DOCUMENT CONTROL PROCESSING FORM

File Number:	DESN0218 Item No. 02		
Document Date:	12/21/21		
Document Type:	Plans		
DCPF Author:	Rachel Altona		
Subject:	Final: Drainage Plans and Profiles		
To (Company):	WSDOT	To (Individual):	Wendi Dubach / Feather Gordon
From (Company):	Jacobs	From (Individual):	Heather Weeks
Additional Subject Information and/or Keywords		Schedule Activity:	N/A

SR509
I-5 TO 24TH AVENUE S
NEW EXPRESSWAY

DRAINAGE PLAN

PLAN REF. NO. DP03

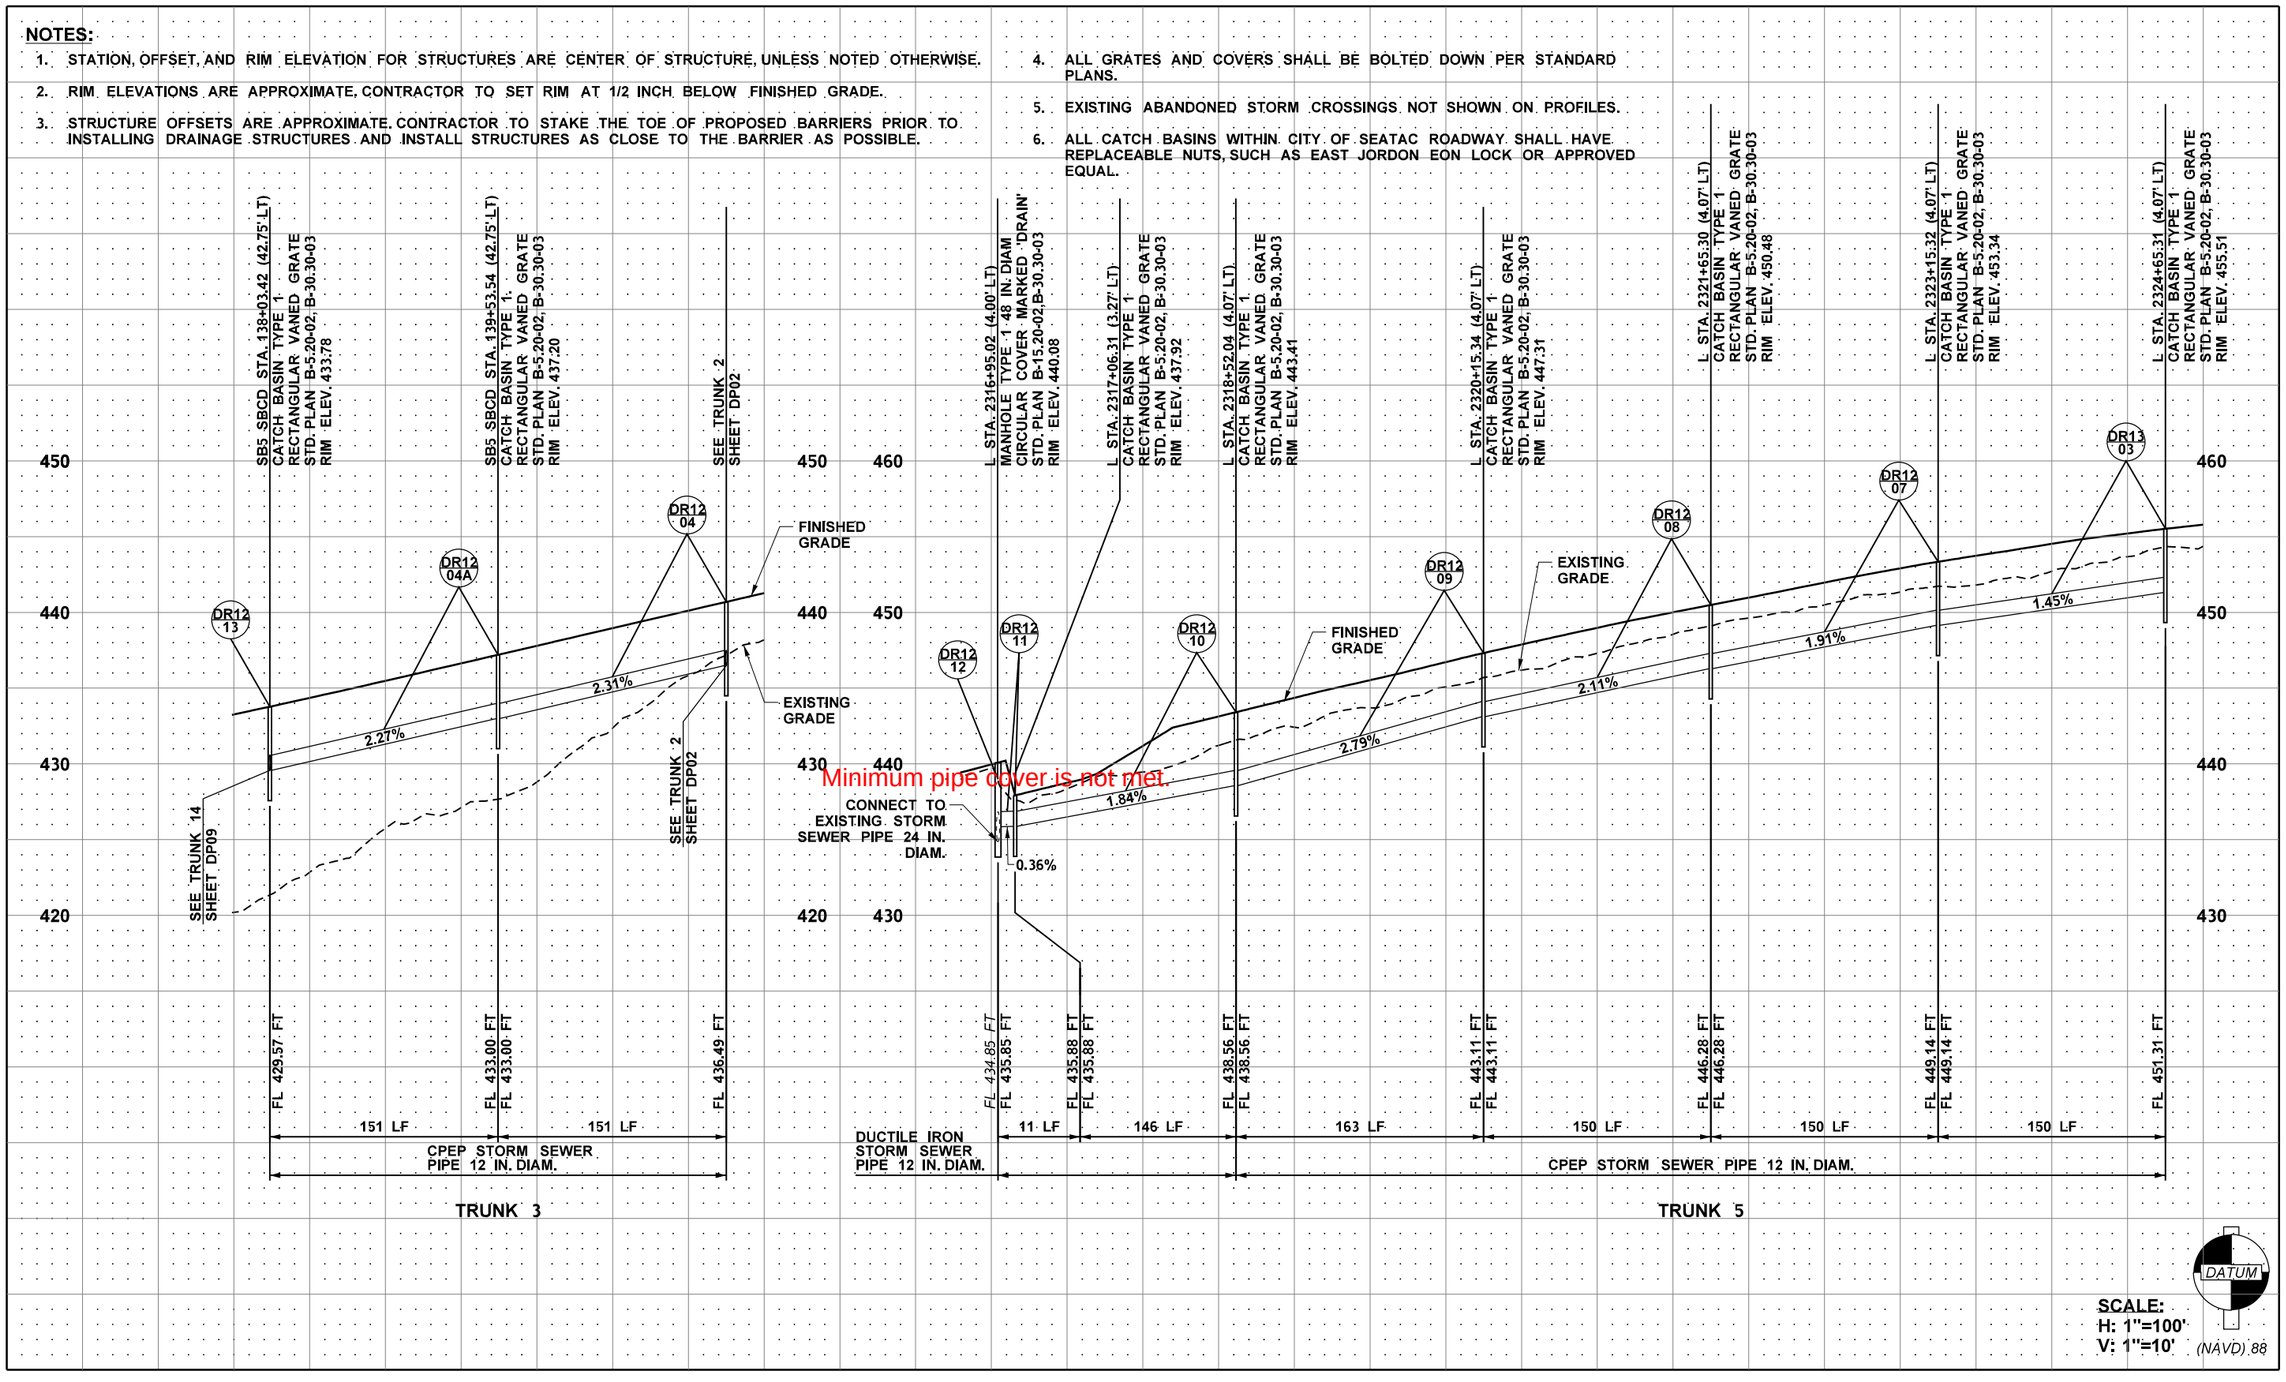
Minimum pipe cover is not met.

PLAN REF. NO. DP09

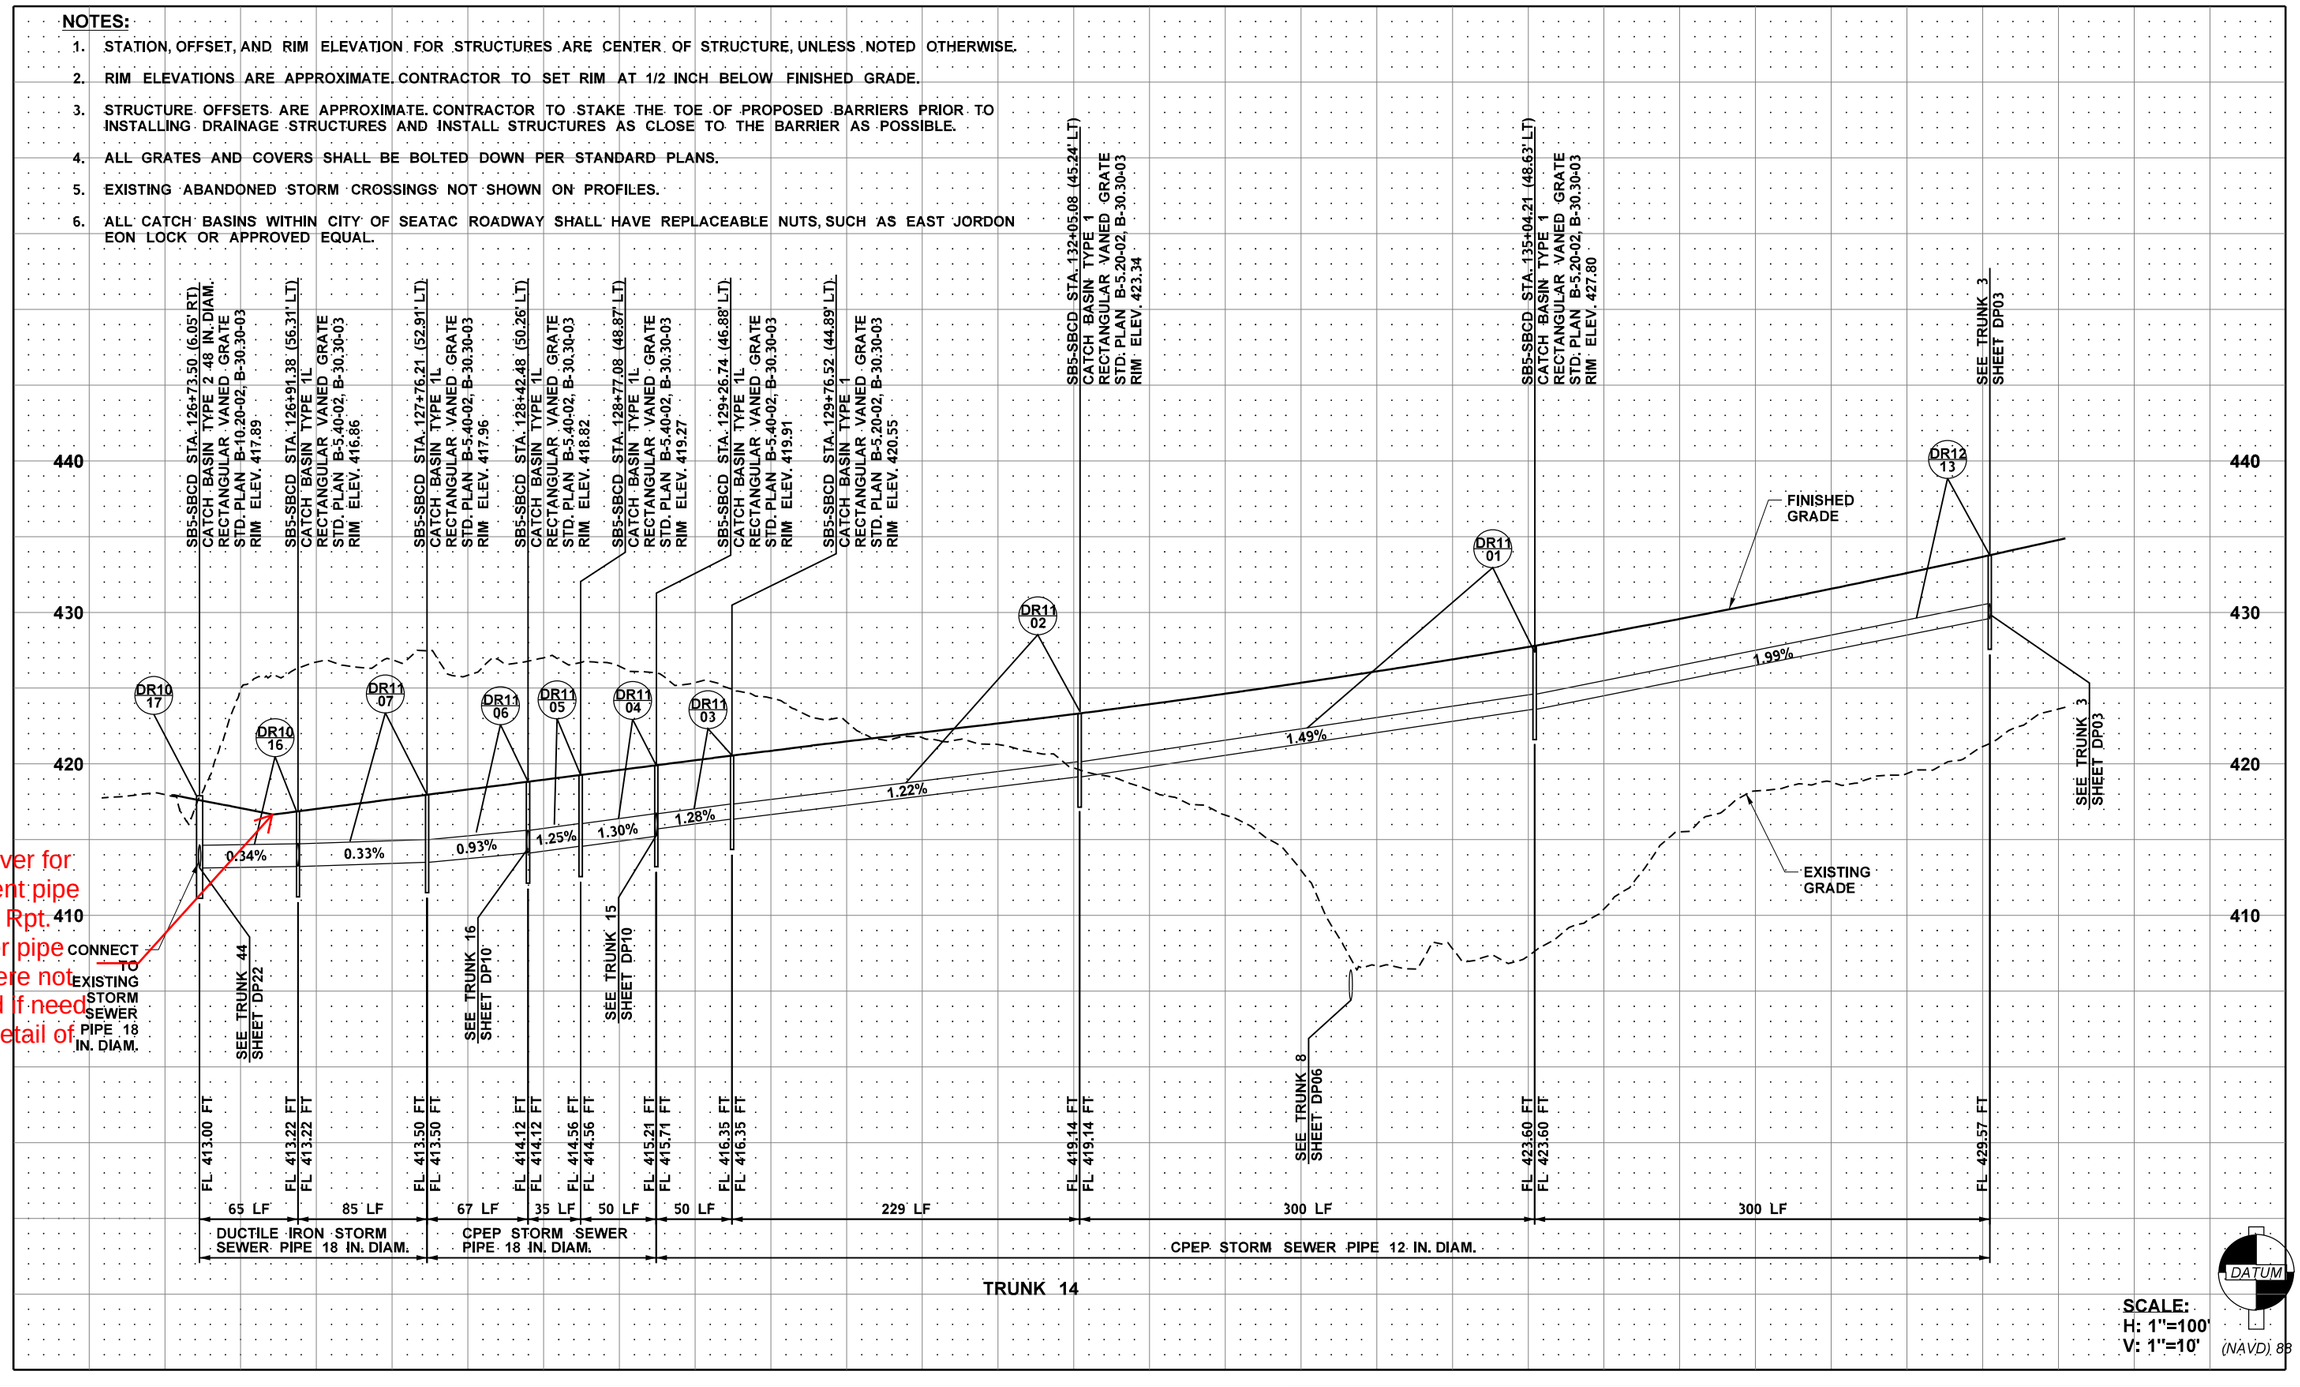
Justify pipe cover for this replacement pipe section in Hyd Rpt. Note why other pipe alternatives were not called out, and if need be provide a detail of pavement

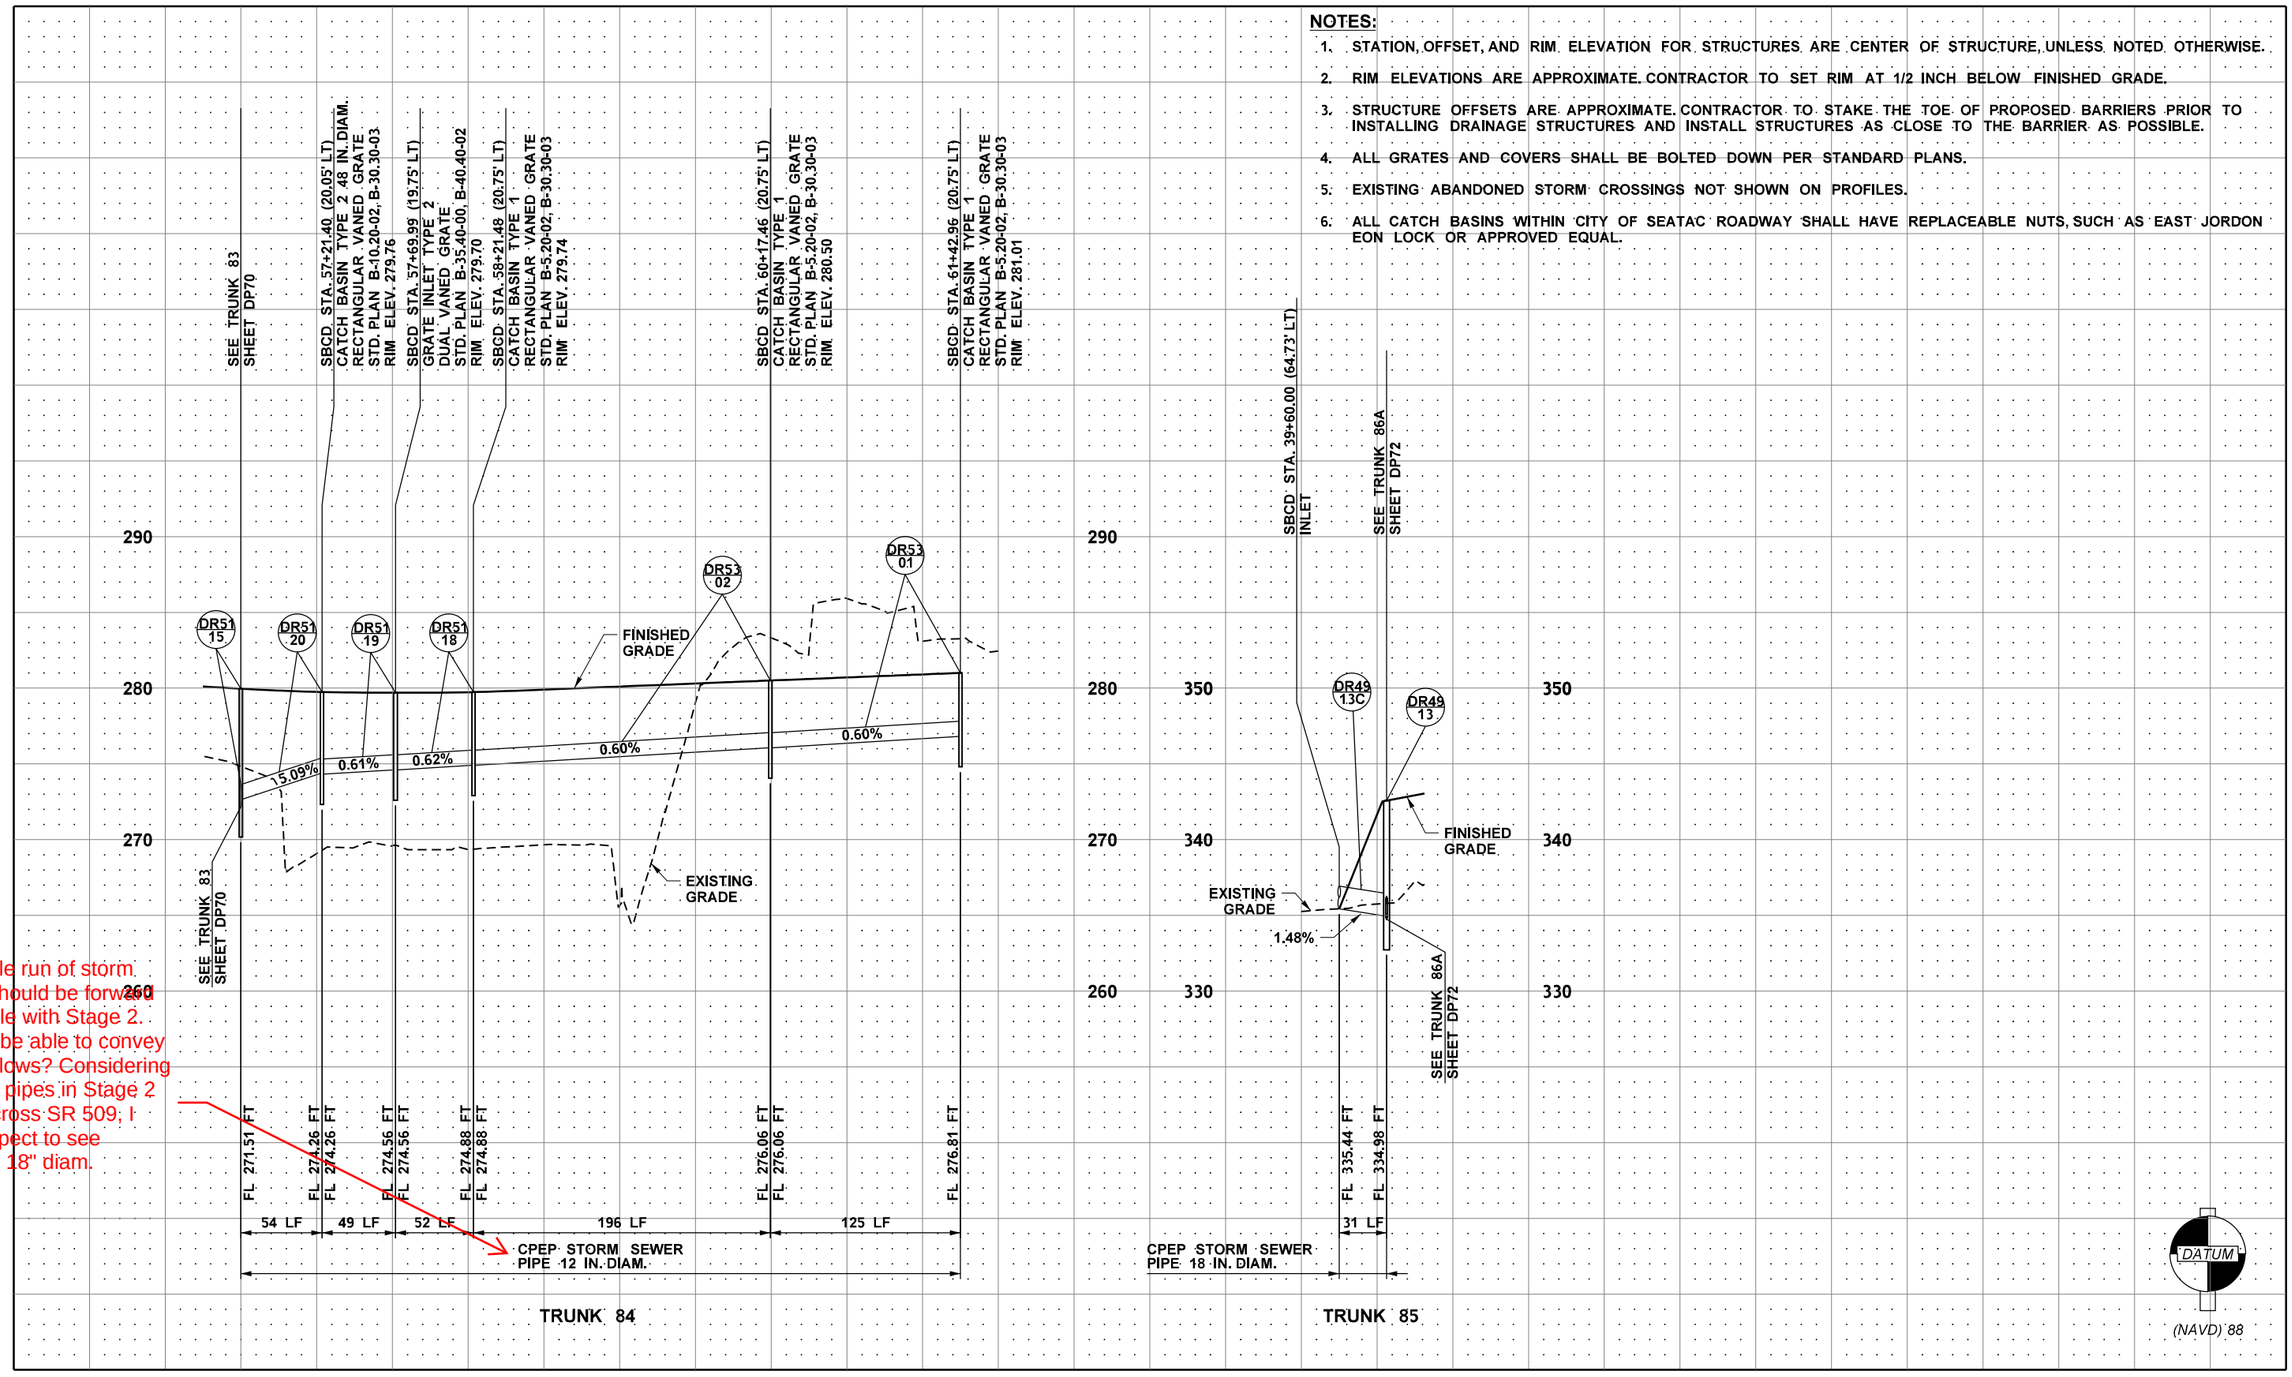
This whole run of storm sewers should be forward compatible with Stage 2. Will they be able to convey Stage 2 flows? Considering there are pipes in Stage 2 that will cross SR 509, I would expect to see minimum 18" diam.
